EtherBox

> Sep 21, 1983 3Com Corporation

Subject: Interrupt problems with 3COM I/F

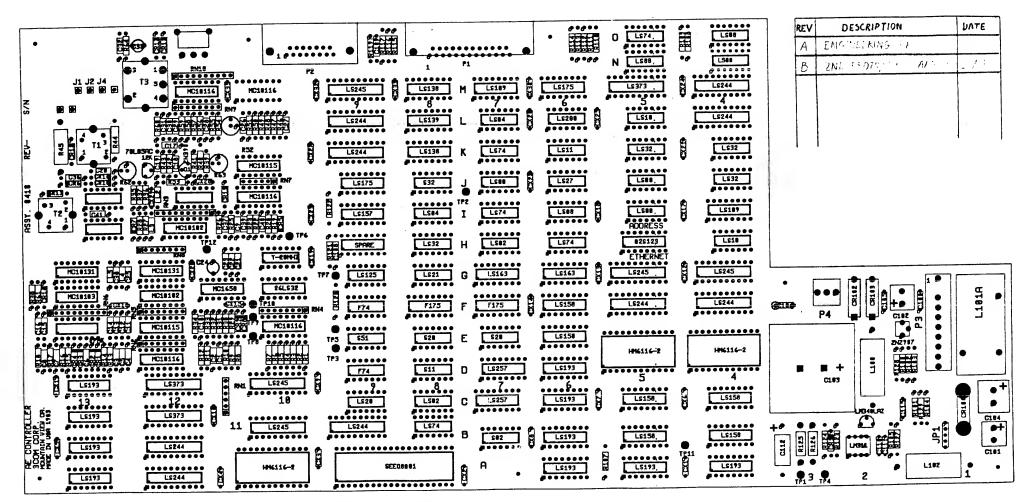
The basic problem stems from the 6522 characteristics and the manner in which it must be used in our 2-port card. 3COM had been assuming that our board was capable of "latching" interrupt events on the 2-port card. Hence, they do not latch the BSY line (used for interrupt control). Whenever the A-port of the 6522 is accessed (as it must for data transfers), the interrupt flag gets cleared inside of the 6522; this, in turn, prevents the 6522 from generating an IRQ into the Lisa interrupt system.

Within the E-Box, the EDLC INT line is gated (via the E-Box's System Interrupt Enable) directly to the BSY line. The EDLC keeps its INT asserted until someone reads the corresponding status register. For transmits, the Host (Lisa) reads the Transmit Status Reg; hence, INT (BSY) will stay asserted. However, the E-Box always automatically reads receive status -- storing it into the receive buffer -- from the EDLC. Hence, the INT (BSY) line is asserted for only a brief instant -- on the order of 1-2 usec. This is just barely long enough for the 6522 to sense the edge-triggered CA1 line (coming in on BSY) and "latch" the interrupt.

However, any activity occurring over the 2-port card (e.g., setting up a transmit or reading the other receive buffer), will cause the latched interrupt condition to be cleared. This causes the interrupt to be "lost". This has been noted by Sunny and is probably the source of problems noted by Frank.

My suggested solution is to include the RBSA* and RBSB* lines as terms in the input to the interrupt gate. Thus, the BSY line would be asserted whenever SIE is true and (the EDLC INT line is asserted or either receive buffer is available to the Host). This, in effect, latches the receive interrupts within the E-Box. BSY would go away when the Host (Lisa) reads the Transmit Status Reg (in case of a transmit complete) or gives the receive buffer(s) back to the E-Box (for receive interrupts).

(11:00, 27-May-83) The 3COM solution (as per conversations with Al) will be to actually latch the INT signal within the E-Box. This is the cleanest solution.

There is still a "minor" problem which must be resolved by software. The BSY interrupt is edge-triggered. Even with the suggested change, the leading edge of BSY could be "lost" due to the 6522 problem; this only happens when a "driver" is using the I/F to talk to the E-Box. However, the state of the BSY line is also readable via the PB1 input. Since the interrupt is latched (assuming some change similar to that proposed above is made), the Host can sense if BSY is asserted before waiting for an interrupt. If it always does this after using the I/F, and "fakes" an interrupt, the interrupt will not get "lost" and all will be well.

The software kludge for existing E-Boxes involves checking, in software, the conditions in my suggestion to a hardware fix. I.e., after playing with the I/F, the software must poll both PB1 and ASR. If either PB1 is asserted or either of the receive buffers has been given back to the Host (Lisa), then an interrupt must be faked. This is done by pushing a dummy interrupt status onto the stack and jumping to the entry of the interrupt handler. (I am enclosing a copy of my code to do this as a sample.)
